World Forum for Harmonization of Vehicle Regulations

Working Party on Lighting and Light-Signalling

UN Regulation No. 48 (Installation of lighting and light-signalling devices):

Proposal for a new 08 series of amendments to UN Regulation No. 48

Model A

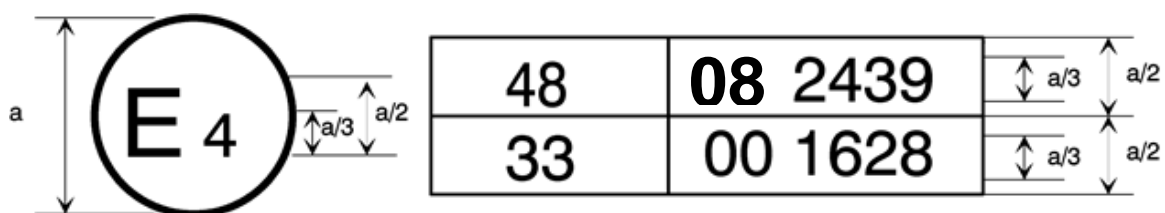
Annex 2, amend to read:

The above approval mark affixed to a vehicle shows that the vehicle type concerned has, with regard to the installation of lighting and light-signalling devices, been approved in the Netherlands (E4) pursuant to UN Regulation No. 48 as amended by the **08** series of amendments. The approval number indicates that the approval was granted in accordance with the requirements of UN Regulation No. 48 as amended by the **08** series of amendments.

28. Editorial changes were introduced to update the number of the series of amendments in the marking examples.
